ADDENDUM NO. 3

Date: August 21, 2023

Issued by: Sacramento City Unified School District

Project: **Project #: 0510-465**
0510-465 CKM/Fern Bacon/Matsuyama/Parkway/Rosa Parks and Sutterville
Security Improvements: Group 2

C1.0.1

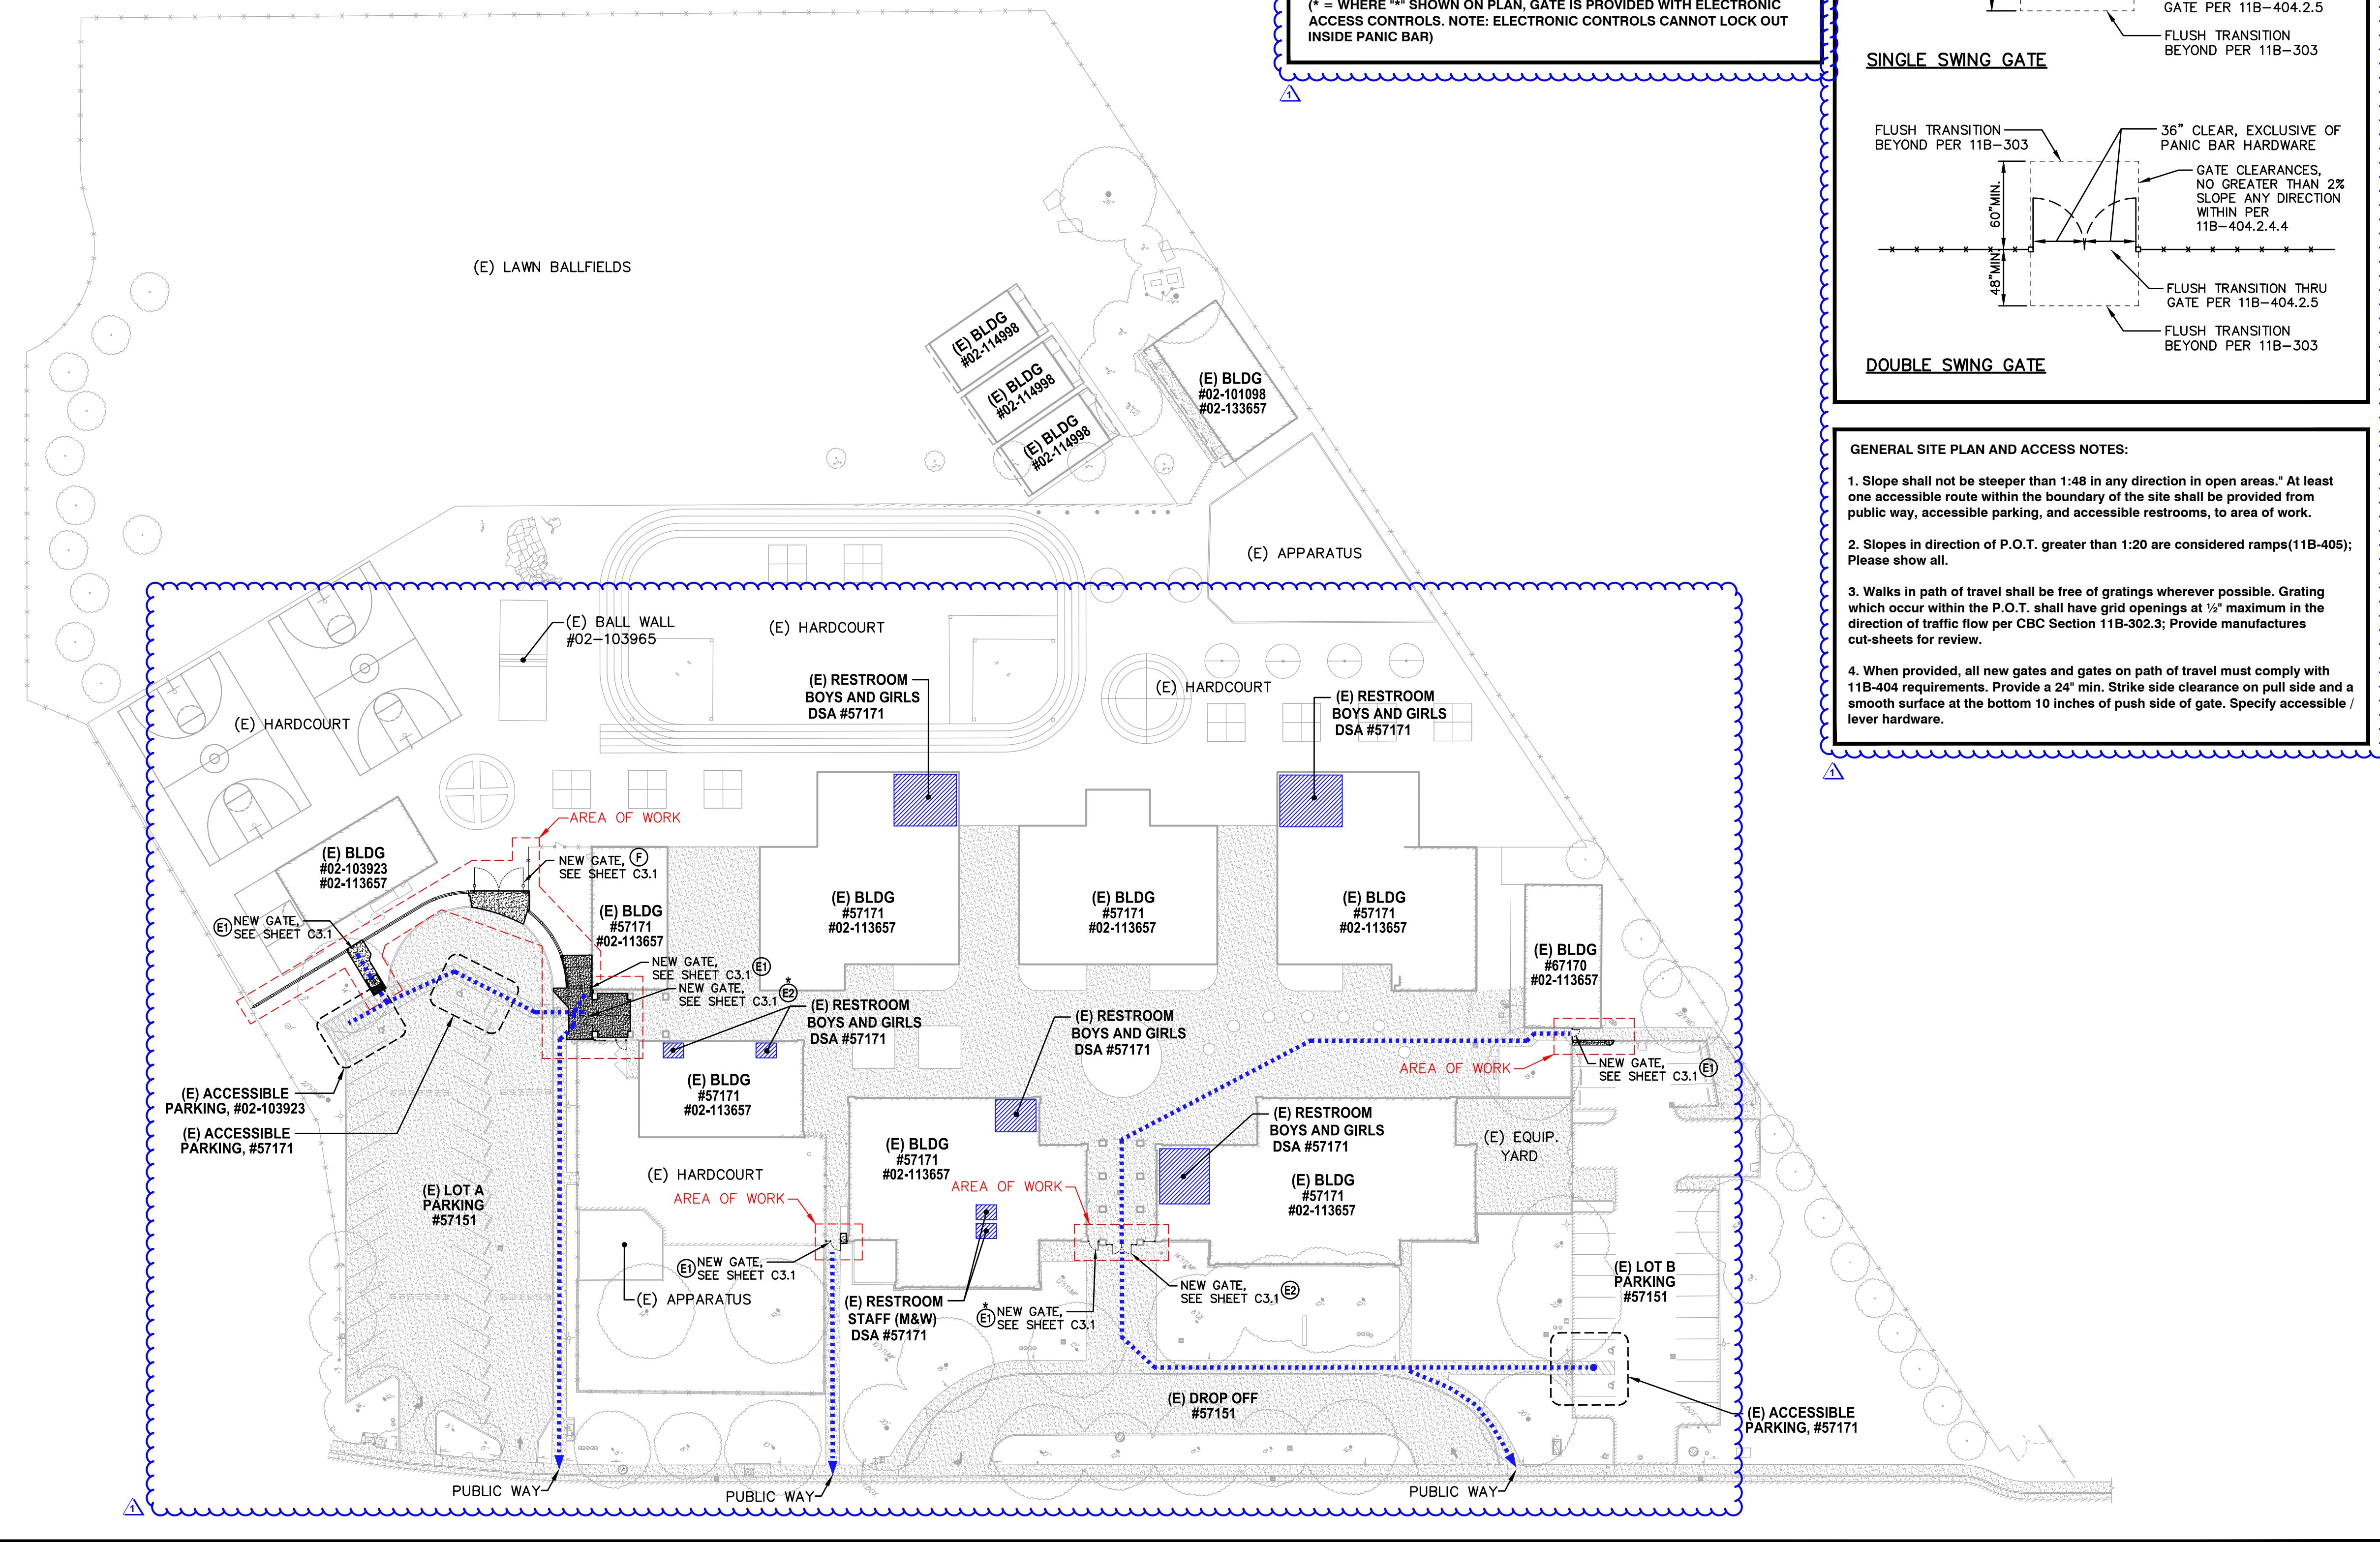
Sheet C1.0.1

- Site access plan updated with additional references.
- Gate legend added.
- General access notes added.
- Typical gate clearance details added.

SHEET NO. C1.0.2

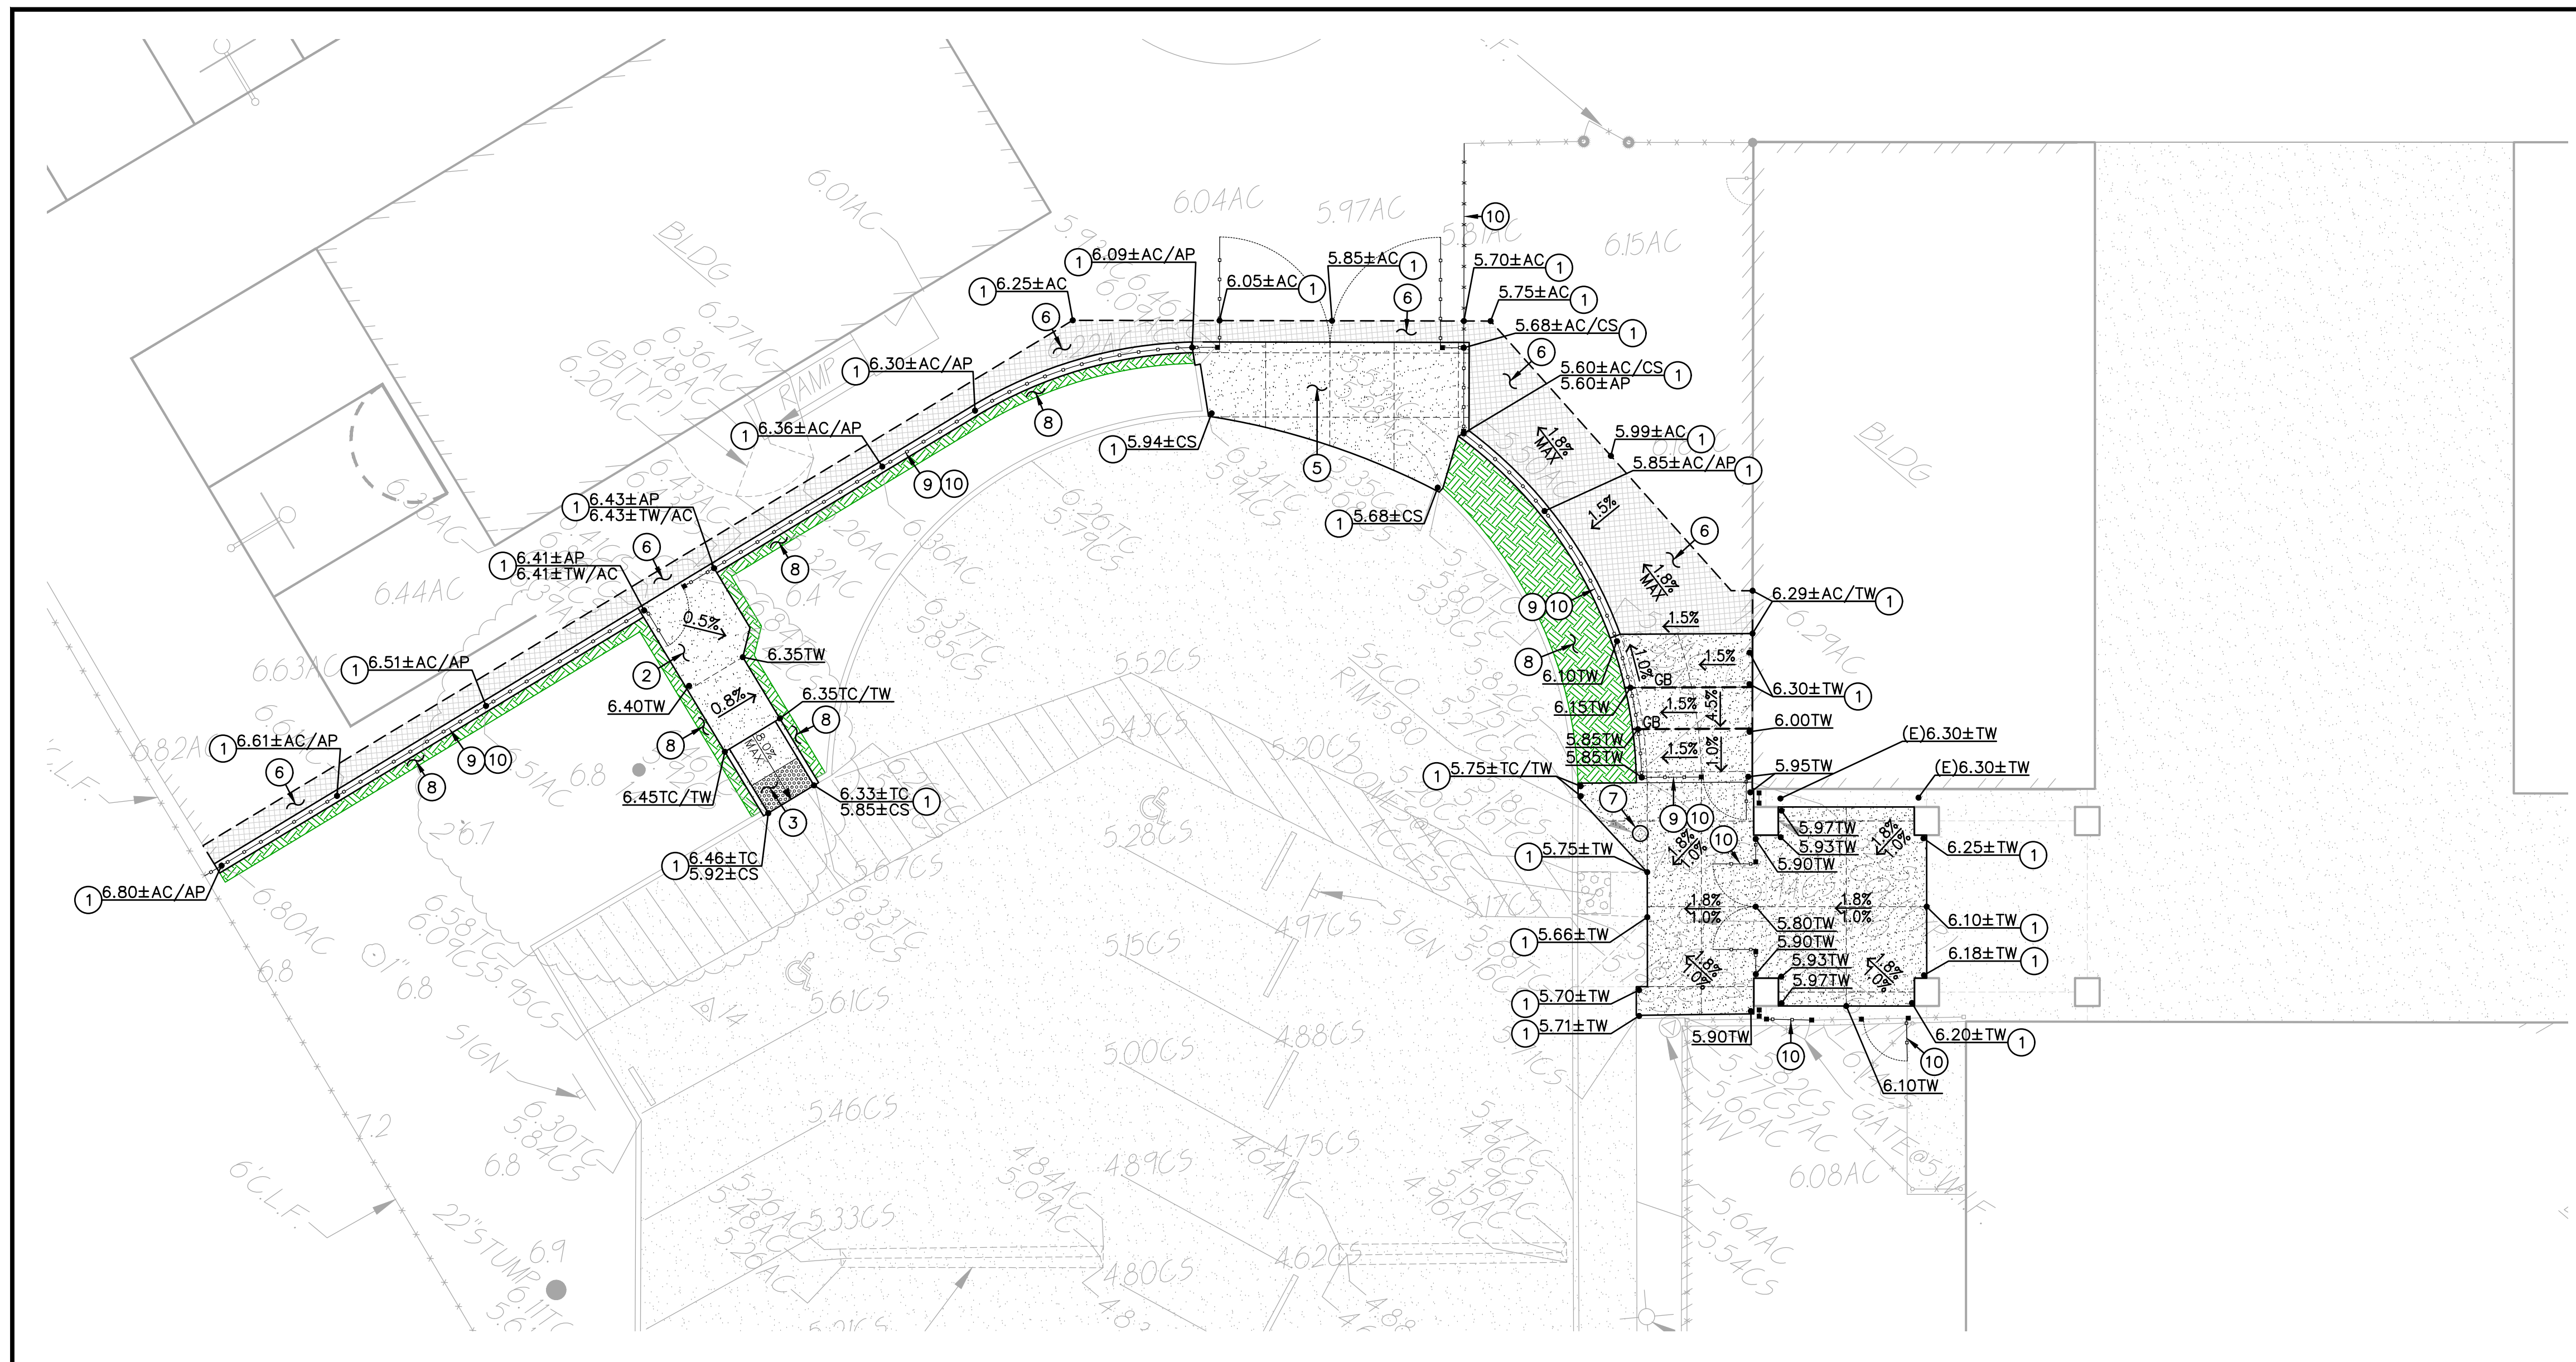
Sheet C1.0.2

- Site fire plan updated with additional references.
- Multi-purpose egress analysis provided.

SHEET NO.
C1.0.1

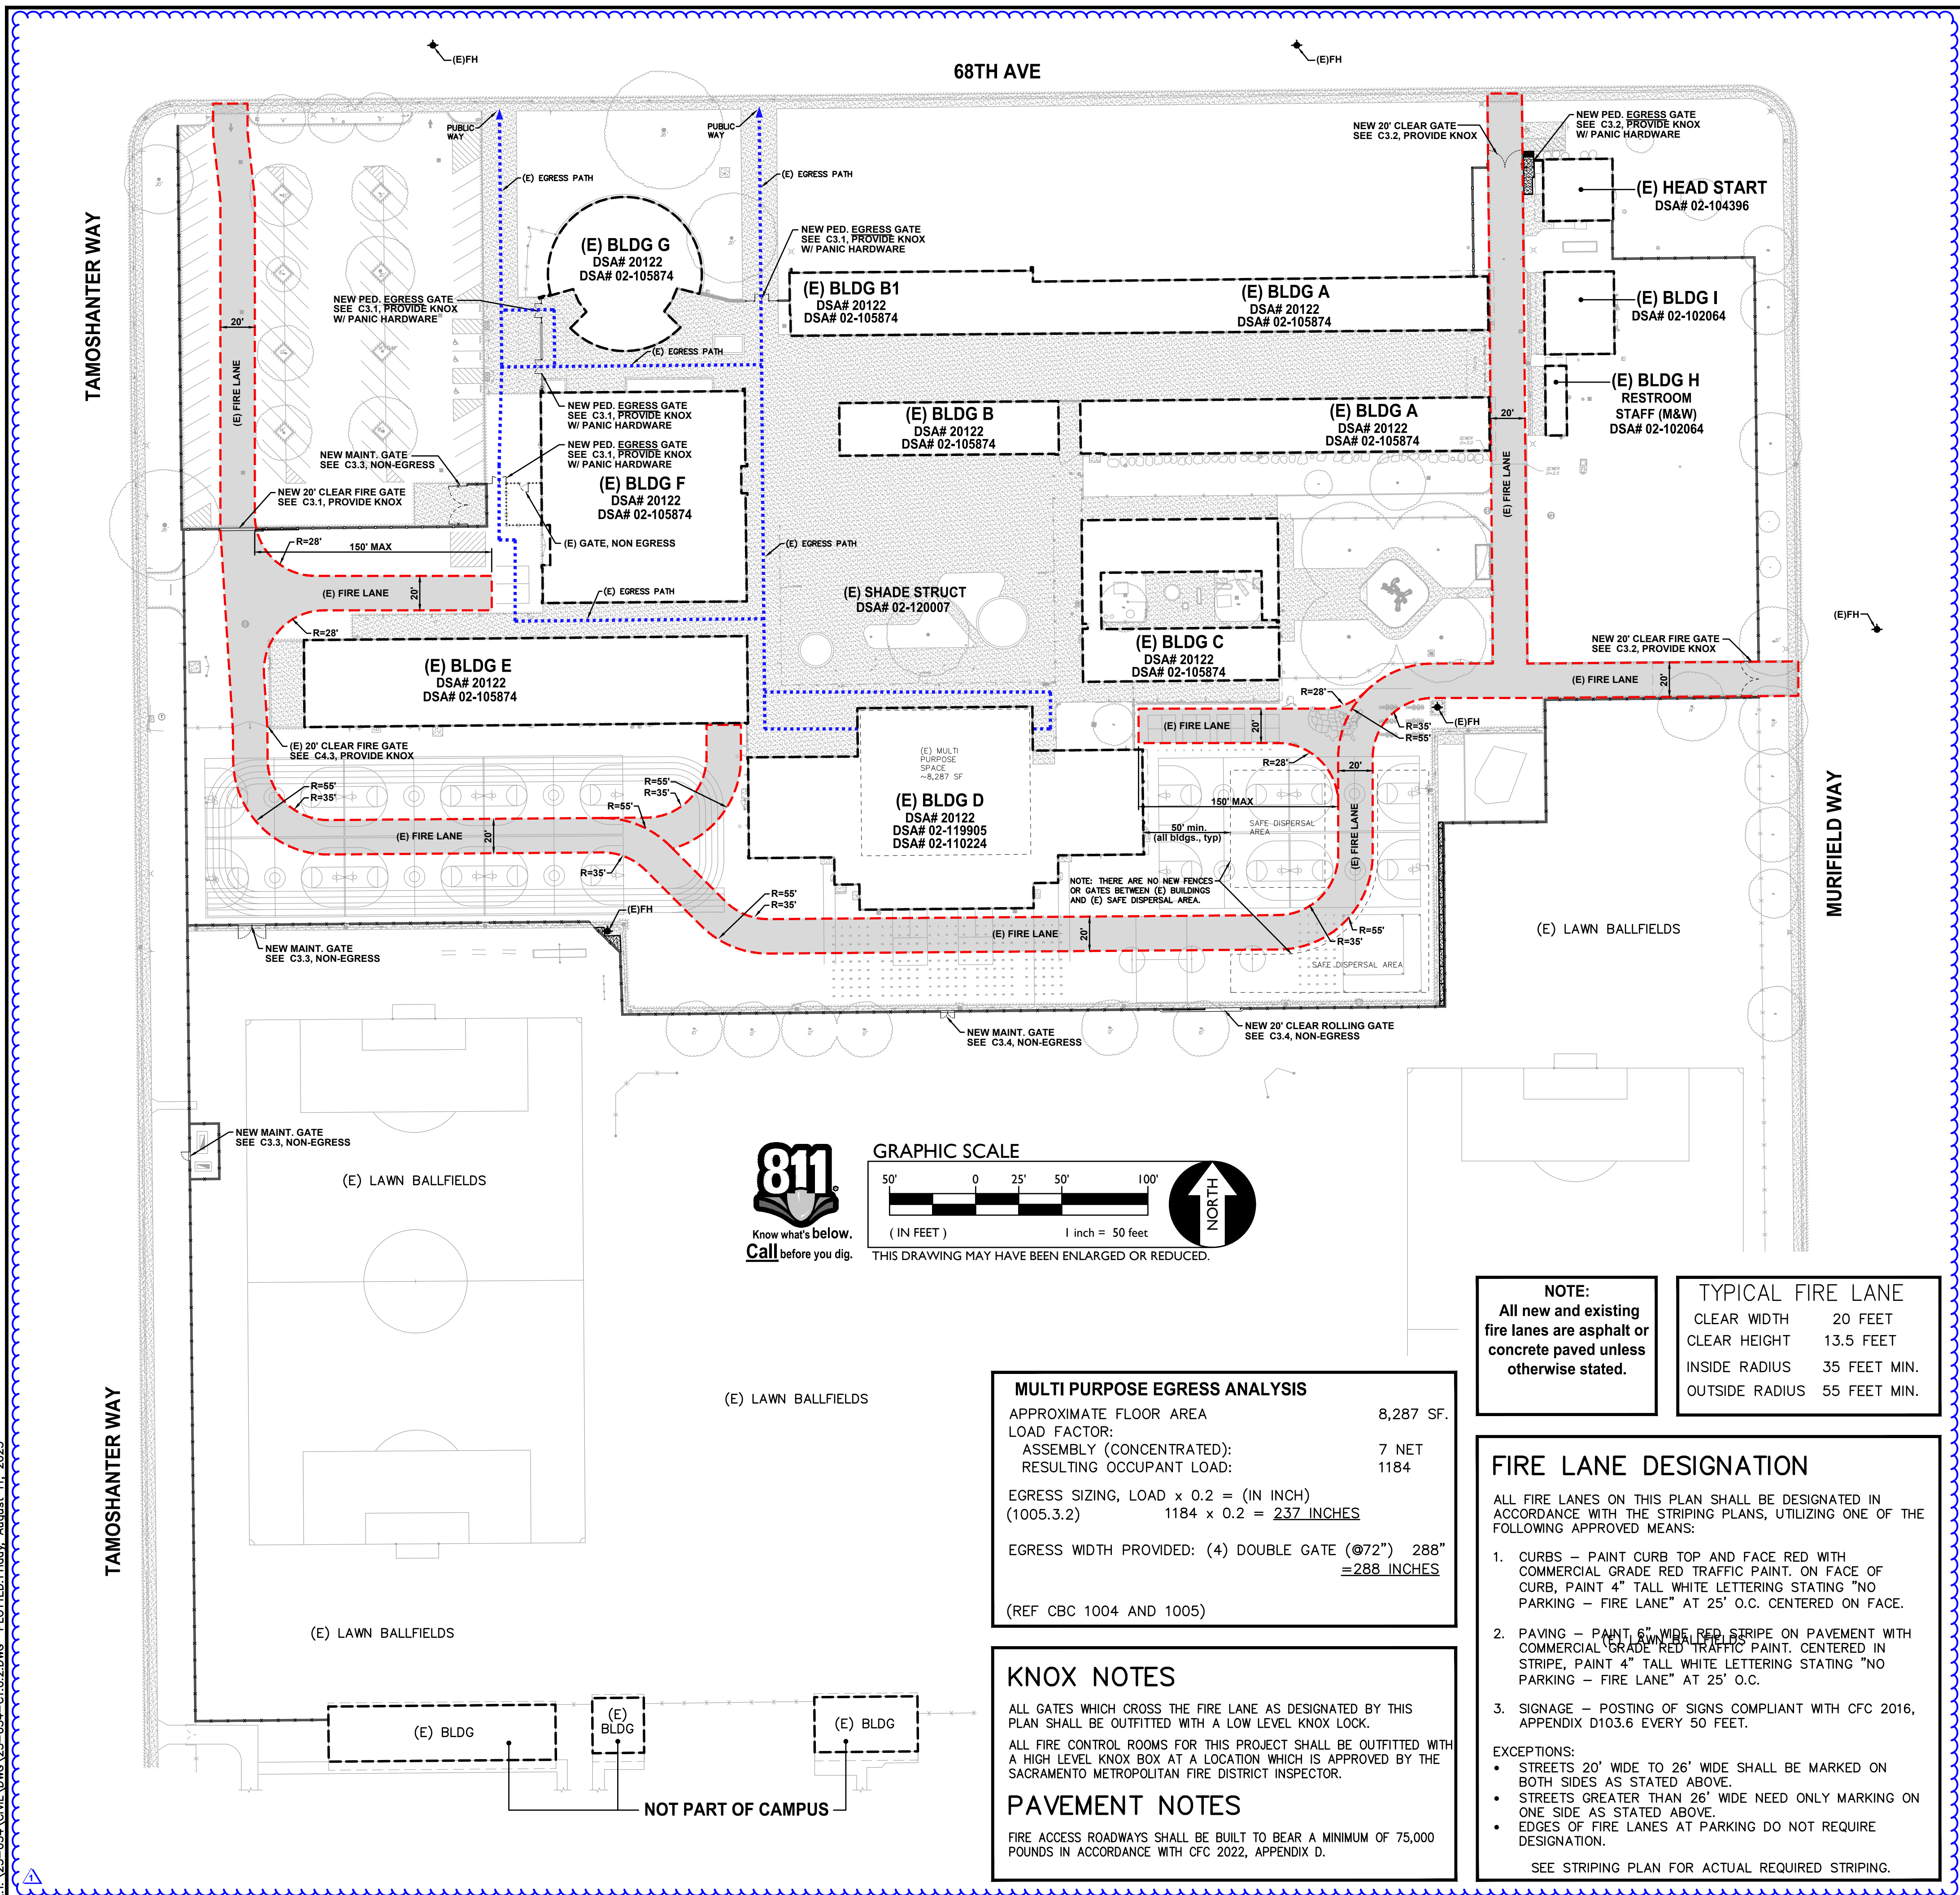
Sheet C1.0.1

- Site access plan updated with additional references.
- Gate legend added.
- General access notes added.

- Typical gate clearance details added.
